SERVICE BULLETIN No. 157

E-60 and E-60H Quik-LiftTM Units SEAL REPLACEMENT (Part # 15686)

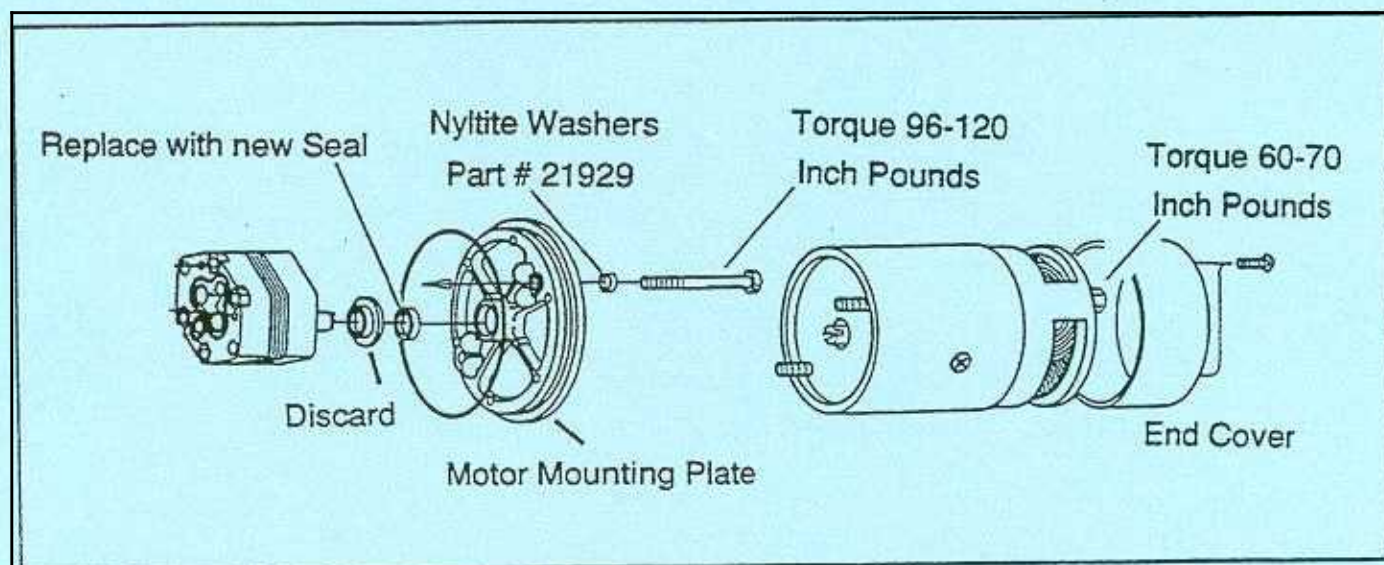
Under Meyer Products continuing Product Improvement Program, a new Pump Shaft Seal is now available. The part number for the Shaft Seal has not changed.

- F. Assemble new (green) Pump Shaft Seal (Part #15686) into the Motor Mounting Plate.

Caution: Care should be taken not to distort seal during assembly.

When Seal is bottomed out in casting, seal will extend past casting approximately 1/16th of an inch.

- G. Reassemble Motor Mounting Plate using new Nyltite washers on Mounting bolts. Torque bolts to 96-120 inch Pounds.
